Re: 2400 E Atlantic Ave Pompano Beach, FL

Florida Power and Light Response Letter

PZ25-12000001

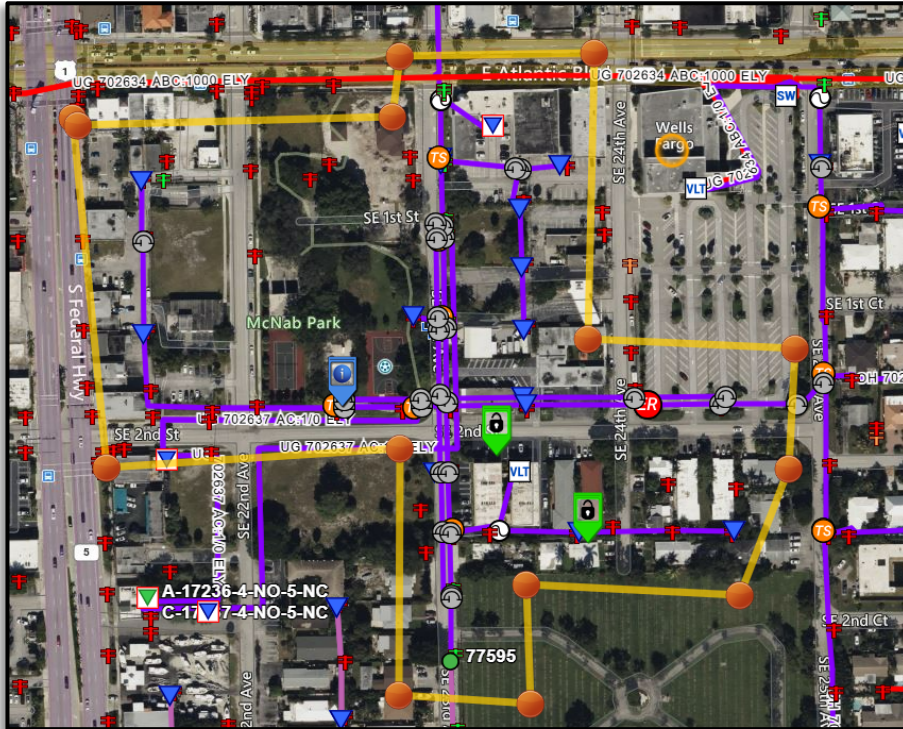
Additionally, while the 1000 foot or 2 block requirement is what we are required to offer for consideration, I would like to point out that the existing facilities on the south of the property heading east along SE 2nd St would likely see a net negative impact on the strength of the grid if converted in the event it is limited to this constraint. I highly doubt that our area management team would approve us from an engineering side to perform the conversion unless it encompasses everything on our feeder 702637 that is south of E Atlantic Blvd between S Federal Hwy and SE 25th Ave as this area is fairly congested with a lot of Automatic Lateral Switches [ALS]. To be clear, ALS are a technology that further works to isolate a fault on our lines by first trying to troubleshoot the fault before opening the fuse. An underground equivalent is currently in the testing phase with our product engineering department, but as it stands now, they are not available for implementation in the field. I cannot say with full confidence that, even with the area outlined in the attached image, the area planning team will be agreeable for this reason.
